Need to Replace Components of the High-Voltage Battery - High-Voltage Battery Control Unit / Cell Module; No Mixed Installation Permitted: Observe Specified Approach (103/25)

Vehicle Type: **Cayenne E-Hybrid (9YA / 9YB)**

Concerns: **Replacing high-voltage battery control unit (BMCE) or cell module on high-voltage battery**

High-voltage battery

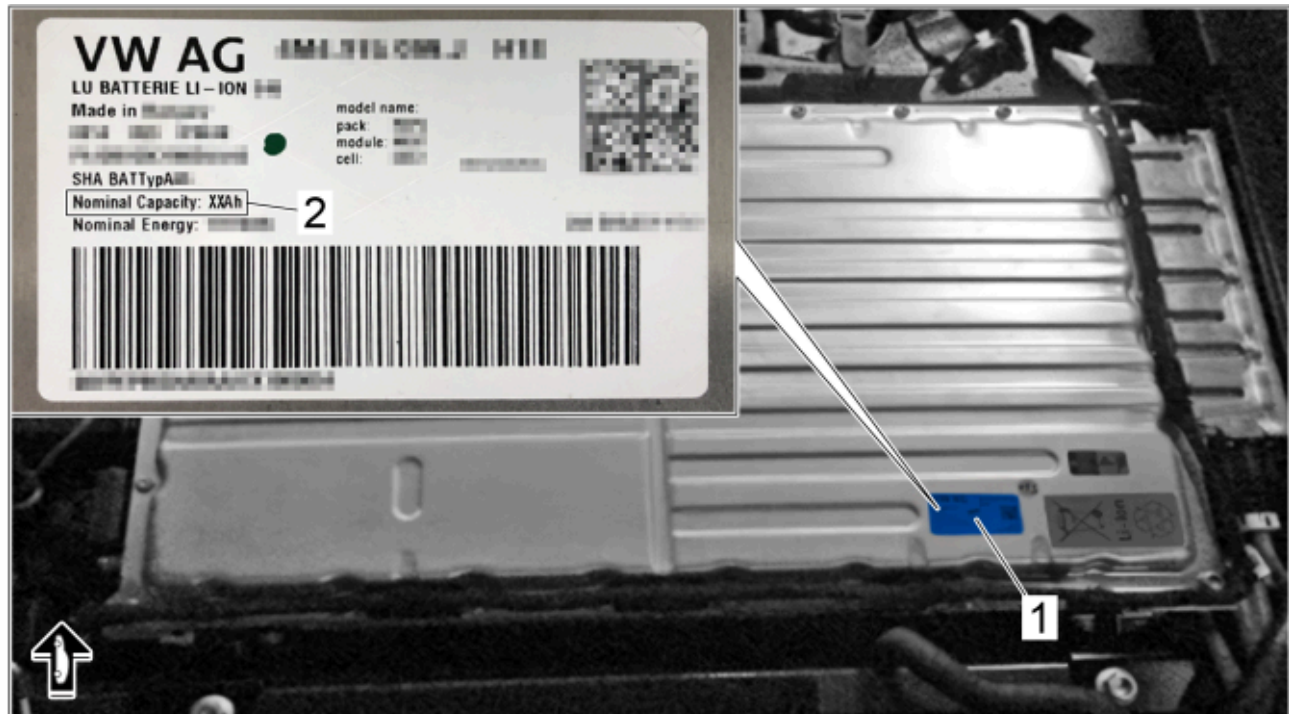
Action: If the high-voltage battery control unit or a cell module needs to be replaced, the actual installed capacity of the high-voltage battery must be checked using the label and factored in accordingly before ordering and installation.

- 1 – High-voltage battery label
- 2 – Specification of capacity 37 Ah / 48 Ah (**check**)
